**Project #22-039**  
**Northwest Fields Business Park**  
**Located at approximately 1000 West 1800 North**

**REPORT SUMMARY...**

*Project Name:* Northwest Fields Business Park  
*Proponent / Owner:* Jason Larsen / Quayle Family Properties  
*Project Address:* Approx. 1000 West 1800 North  
*Request:* Design Review Permit  
*Current Zoning:* Industrial Park (IP)  
*Type of Action:* Quasi-Judicial  
*Hearing Date* August 25, 2022  
*Submitted By:* Russ Holley, Senior Planner

CONCEPTUAL SITE PLAN  
THIS SITE PLAN IS FOR CONCEPTUAL PLANNING.  
THE SITE WILL NEED TO BE SURVEYED TO  
ACCURATELY DEFINE ALL BOUNDARIES,  
EASEMENTS, UTILITY EASEMENTS, RIGHT-OF-WAYS,  
CONFIRM ACCESS LOCATIONS, AND WETLANDS.

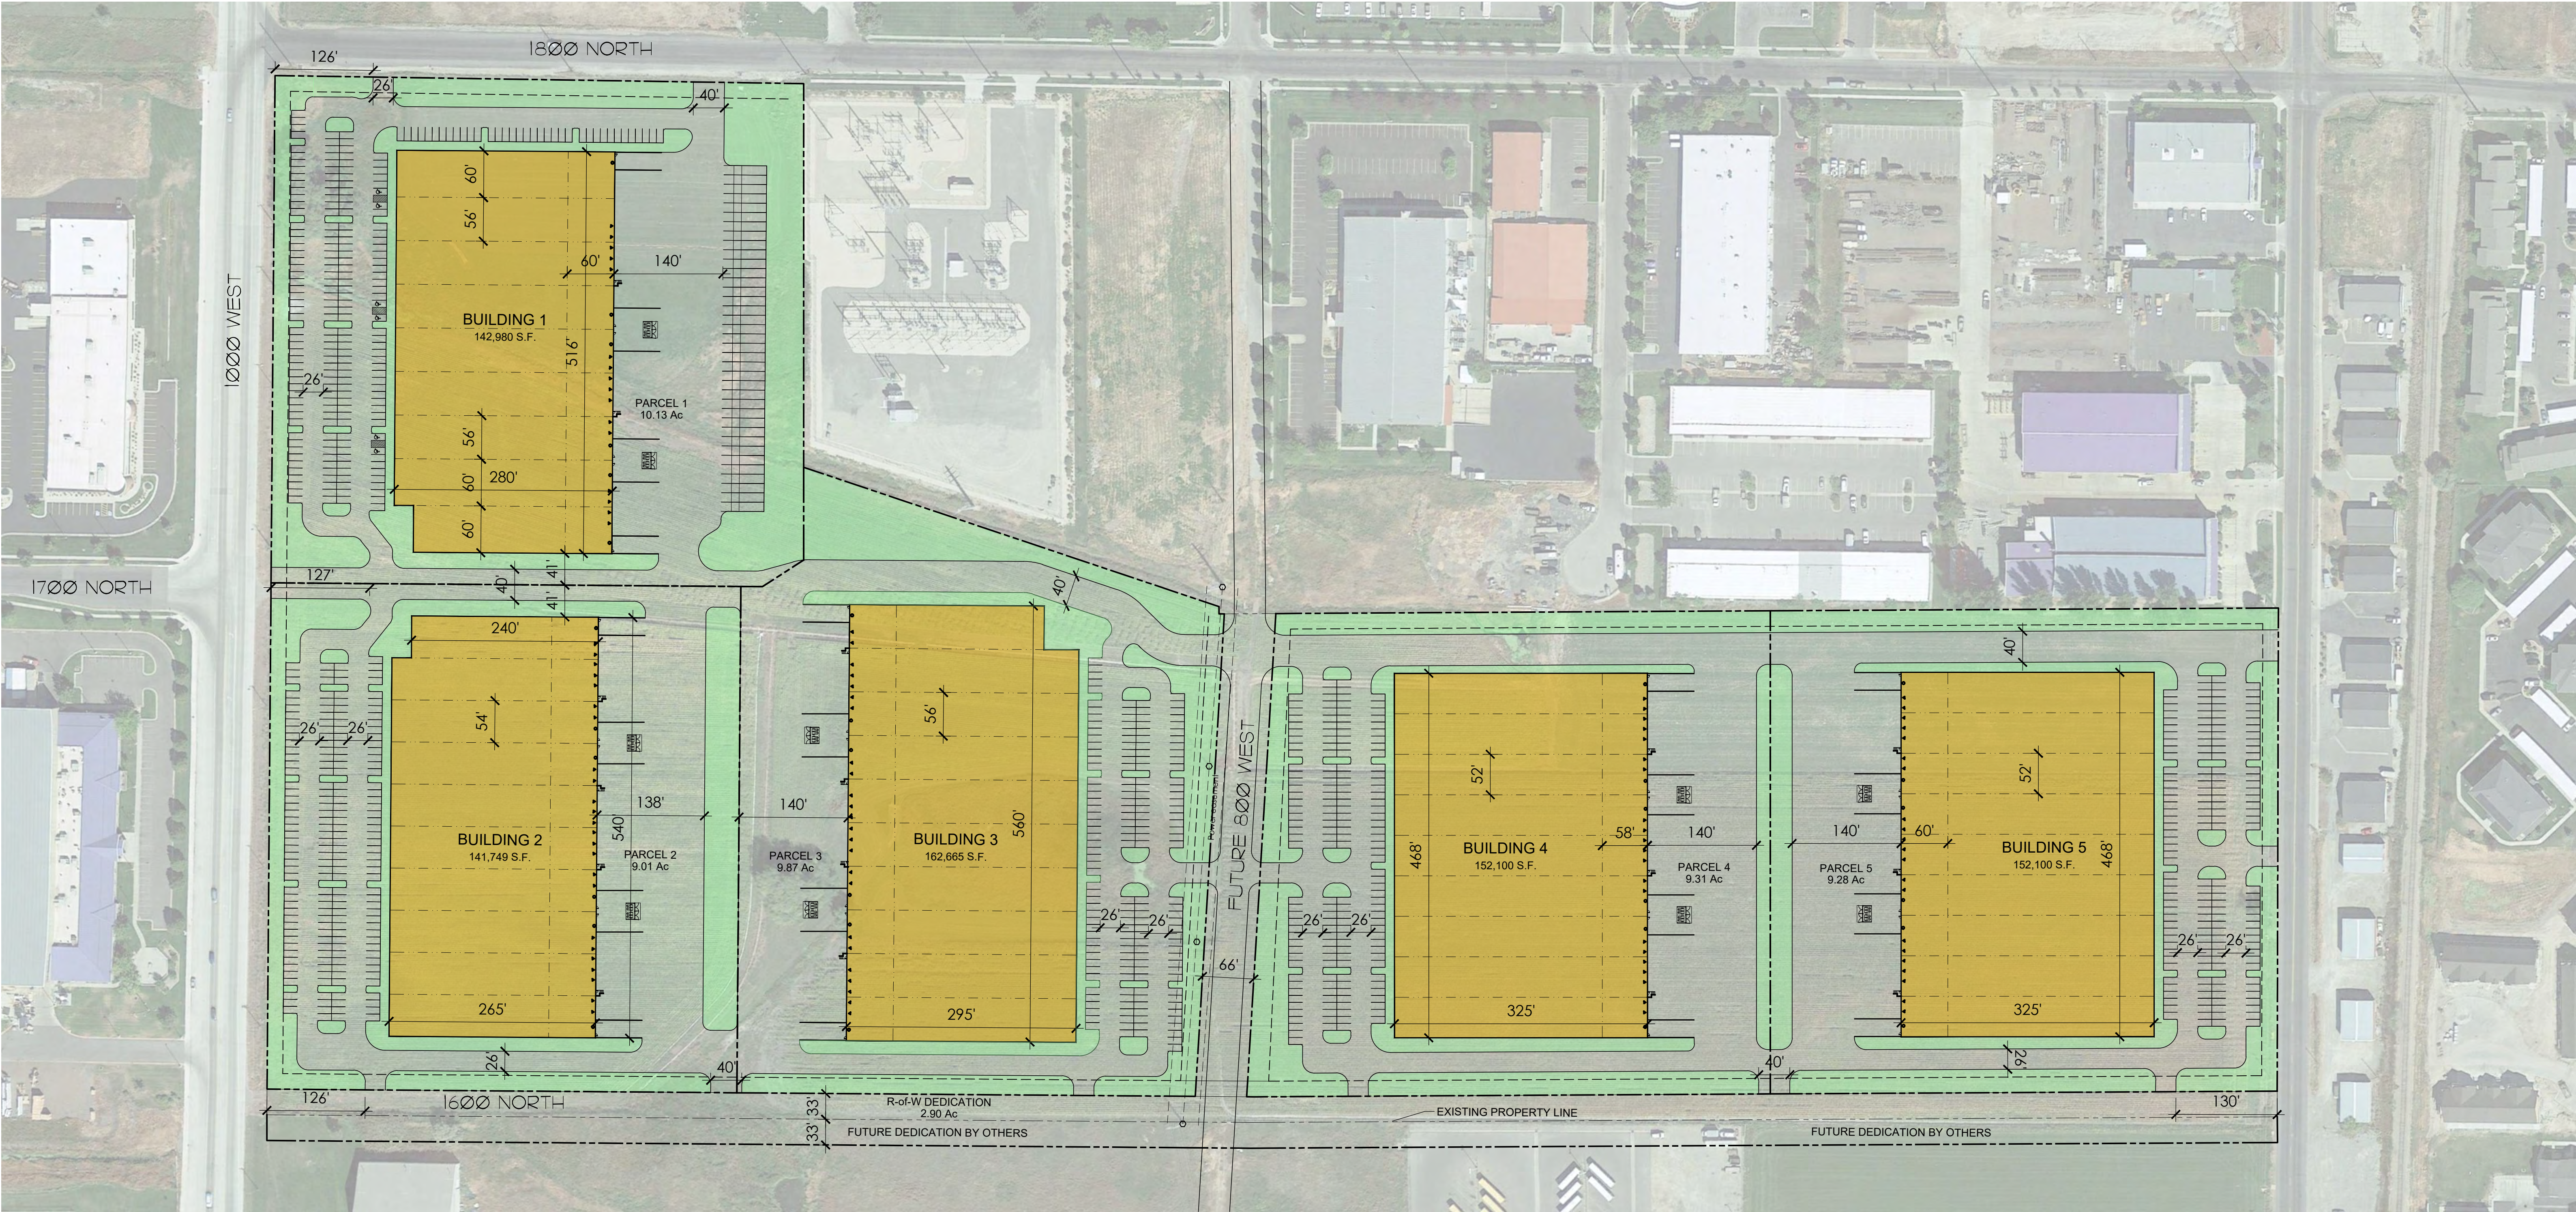
The LDC 17.31.090 requires commercial and industrial sites to include safe and convenient pedestrian circulation from the adjacent streets to buildings, parking areas and other outdoor gathering areas. The submitted "conceptual" site plan does not show sidewalk circulation. There are spaces adjacent to every building and through parking areas to create sidewalk corridors to every adjacent street for sidewalk connectivity. As conditioned with full pedestrian circulation to adjacent street sidewalks, the project complies with the LDC.

When parking areas are proposed in areas adjacent to streets, LDC 17.32.070 requires additional landscaping/buffering to help screen asphalt parking areas. Type “B” screening, additional shrubbery, and trees, is required when a parking lot is within 12’-25’ of the street. This proposed shows parking area adjacent to both 800 West, 1000 North and 600 West. As conditioned with minimum open space (based on net acreage after street dedication) and landscaping numbers and parking lot Type “B” screening, the project complies with the LDC.

- The City has only required a 66' right of way on all other sections o 800 West. The 80' shown is not required to be greater than 66'. Dedicate 33' of right of way for the

future 1600 North street along the southern border of the project site. Dedicate 33 feet along 600 West (from existing centerline) if 33' feet from centerline does not already exist.

3. The Planning Commission utilizes their LDC 17.43.080 approval criteria to approve parking locations as shown.
4. Sidewalk connections shall be made between each building and at least one adjacent street in a direct manner.

5. The Design Review Permit does not authorize a subdivision of the existing parcels. The street dedication plat can be done without further subdividing the project site.
